GRID CONNECTIVITY TO TFL TO SUPPLY 90 MW POWER AND
CONSTRUCTION OF 220 KV LILO GIS

AMENDMENT – IV

NIT, No. PNMM/PC-183/E-4017/NCB Dated 20.06.2022

Sub.: GRID CONNECTIVITY TO TFL TO SUPPLY 90 MW POWER AND CONSTRUCTION OF
220 KV LILO GIS AT TALCHER FERTILIZERS LIMITED, TALCHER, ODISHA

TENDER PURPOSE ONLY

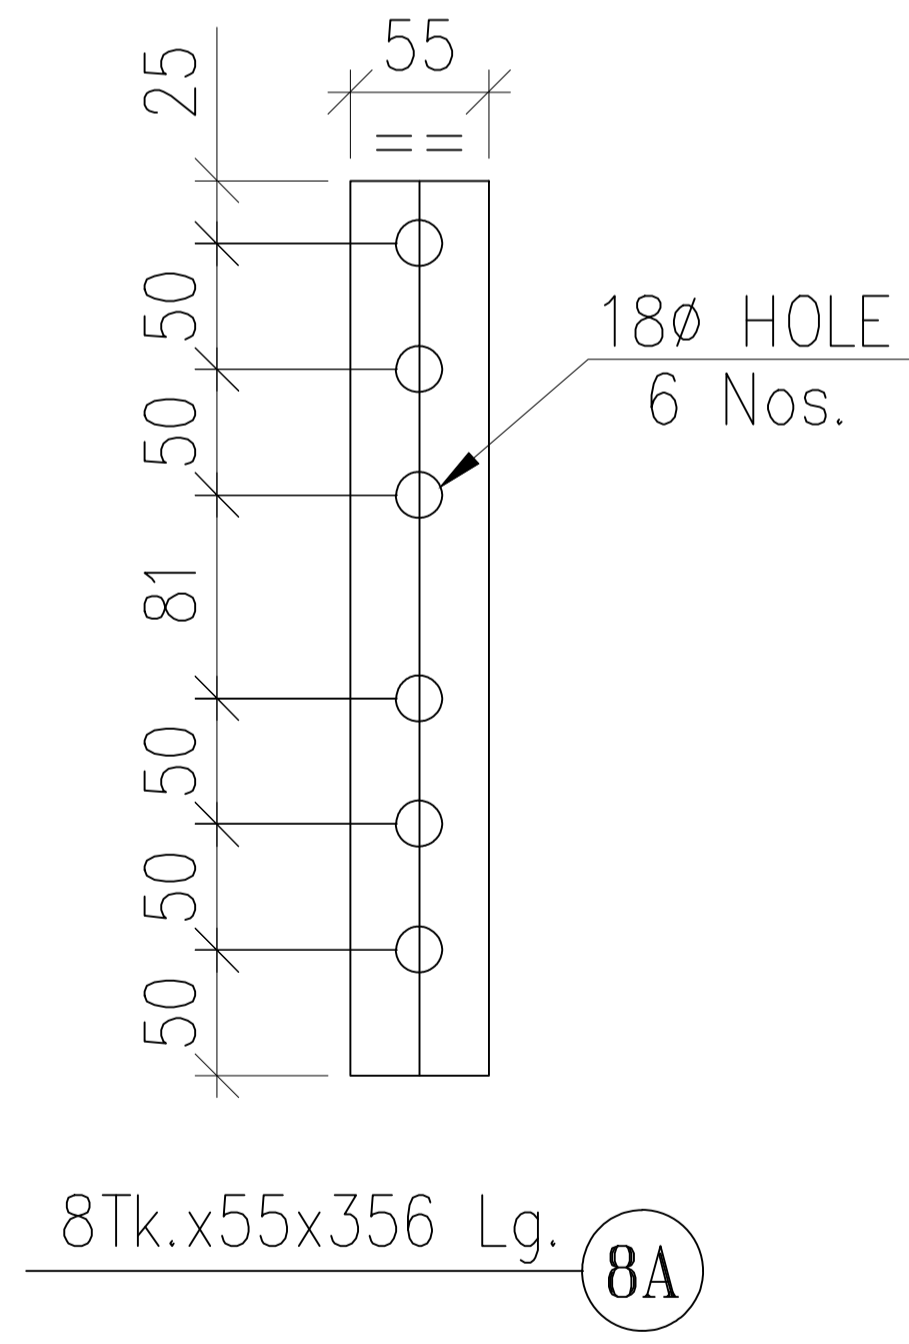
8)	TS	1615 of 1622	Annexure X – IV	Tender Drawings	Tender Reference Drawing of Triple Pole Structure	A	Refer Annexure G – “Tender Reference Drawing of Triple Pole Structure”
